## Development Review Committee

**TO: Howey-in-the-Hills Development Review Committee**  
**CC: J. Brock, Town Clerk**  
**FROM: Thomas Harowski, AICP, Planning Consultant**  
**SUBJECT: Lake Hills Residential Preliminary Subdivision Plan**  
**DATE: November 28, 2023**

December 11, 2023  
Lake Hills Preliminary Subdivision Plan  
Engineering Review Comments  
Page 1

**TO:** Howey-in-the-Hills Development Review Committee  
**CC:** J. Brock, Town Clerk  
**FROM:** Thomas Harowski, AICP, Planning Consultant  
**SUBJECT:** Lake Hills Commercial Preliminary Site Plan  
**DATE:** December 6, 2023

**SITE DATA:**

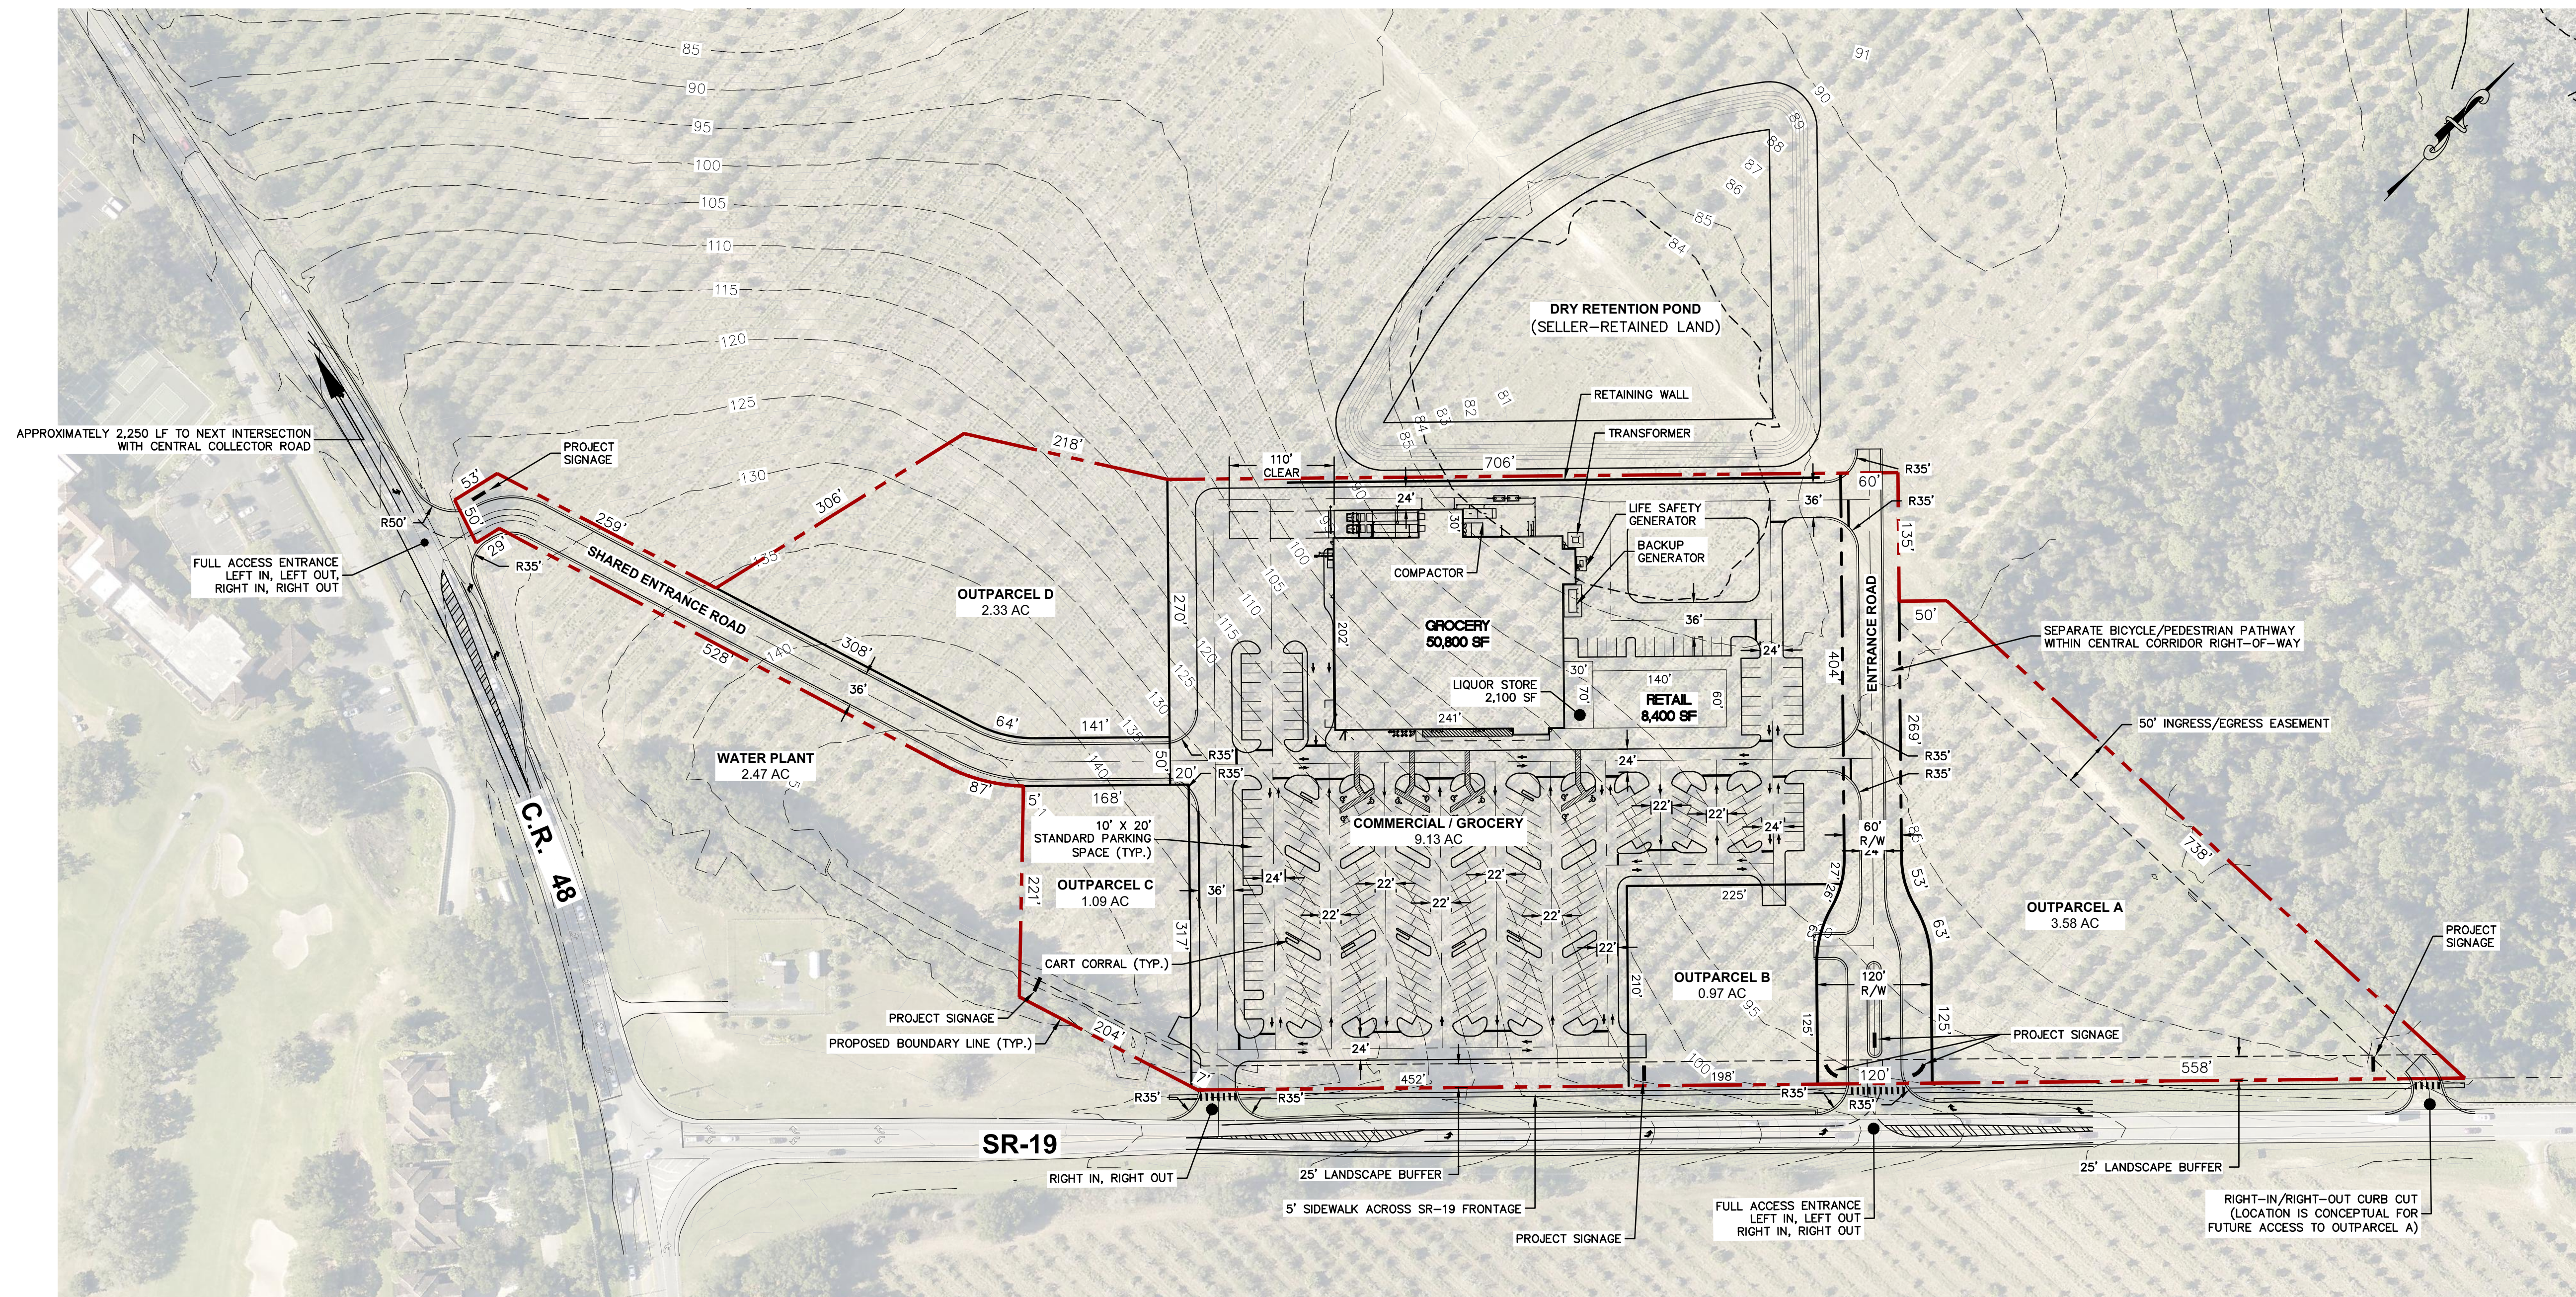
4. The traffic study is still needed.
5. The plan notes state that there are no dedications or reservations, but the collector road is a dedication as presently identified.

9. The commercial plan set identifies the stormwater area as a dry retention area, while the residential plans identify it as a wet retention area. The plans need to be coordinated.

12. The proposed signage locations will need further discussion. The plan shows a free standing sign for each outparcel and a free standing sign at the CR-48 entrance. The signage proposed at the central collector entrance off of SR-19 is unclear as to whether this signage is intended for the residential project, the commercial project or both.

21. The plan shows one retaining wall location along the rear of the commercial site. Are other retaining walls anticipated? If just the one retaining wall is used, the amount of fill will be significant and may affect the outparcels and adjacent roadways.
